Interactive comment on “Decomposition analysis of water footprint changes in a water-limited river basin: a case study of the Haihe River Basin, China” by Y. Zhi et al.

Y. Zhi et al.

Received and published: 18 March 2014

Fig. 1. Location of study area (adapted from website of Haihe River Water Conservancy Commission <http://www.hwcc.gov.cn/pub/hwcc/static/szygb/gongbao2011/>)

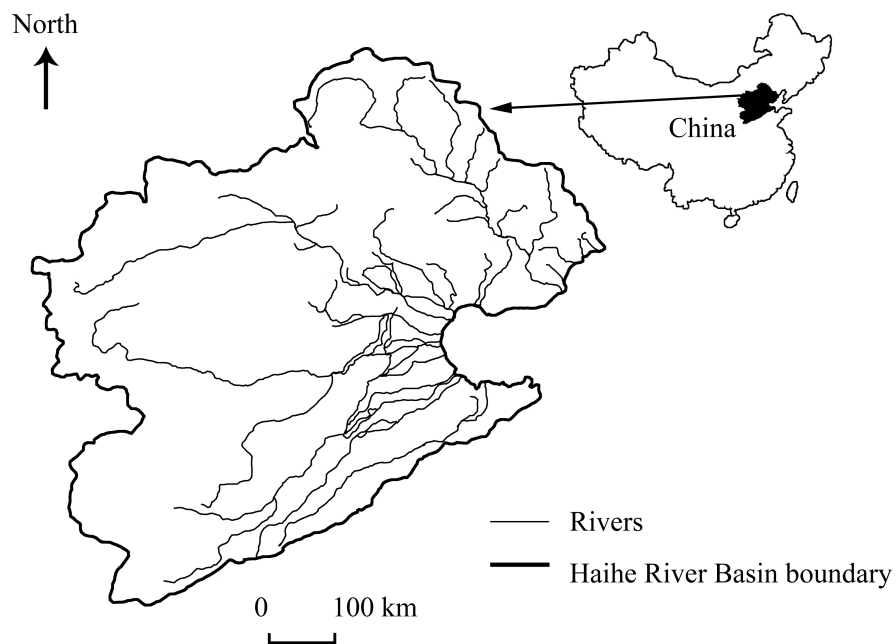
4 The title of 2.1 should be changed as Study area, and a location map should be supplemented in this part; Response: Following this comment, we have changed the title of 2.1 to "Study area" (see page 4, line 21). We have also added the location map as follows, which was adapted from website of Haihe River Water Conservancy.

Fig. 2. WFs in the HRB in 2002

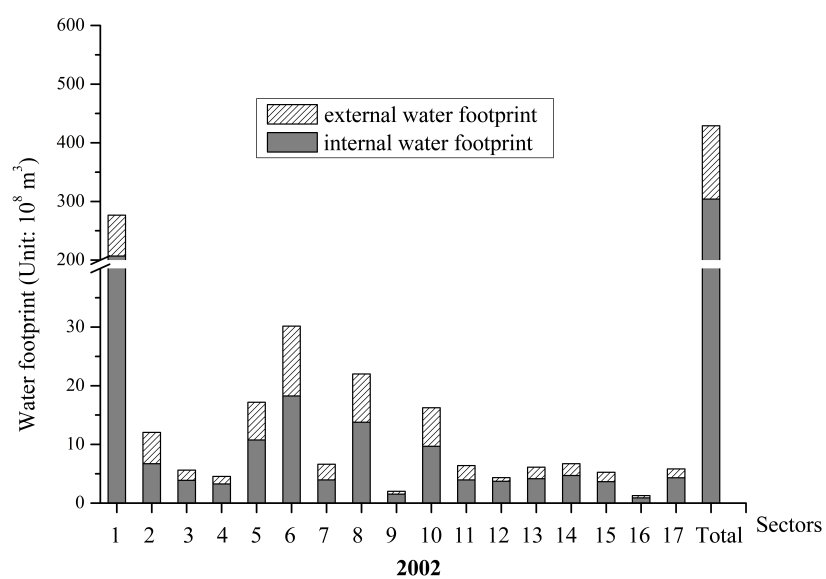
9 The name of X-axis and Y-axis in Fig.1 should be marked. Response: The names of X-axis and Y-axis in Fig.1 (Fig. 2 in the revised version) were added. X-axis meant the number of sectors, and Y-axis meant their water footprints (108 m3).
